Product Change Notice (PCN)

PCN Number: **PCN-0450524R-01**

Product(s) Affected: *SJ-2523-SMT-TR, SJ-2524-SMT-TR*

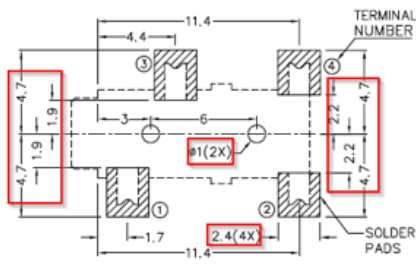
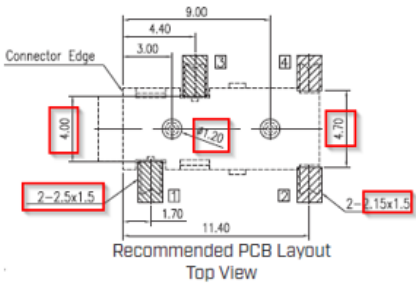
Reason(s) for Change: *Manufacturing process improvements*

Description of Change: *See below images*

MATERIAL	PLATING																																			
terminal 1	copper alloy	silver																																			
terminal 2	copper alloy	silver																																			
terminal 3	copper alloy	silver																																			
terminal 4	brass	silver																																			
plastic	PA6T or equivalent																																				
DESCRIPTION	MATERIAL	PLATING/COLOR																																			
terminal 1	phosphor bronze t=0.25	silver over nickel																																			
terminal 2	phosphor bronze t=0.30	silver over nickel																																			
terminal 3	phosphor bronze t=0.25	silver over nickel																																			
terminal 4	brass t=0.30	silver over nickel																																			
housing	PA10T (UL94V-0)	black
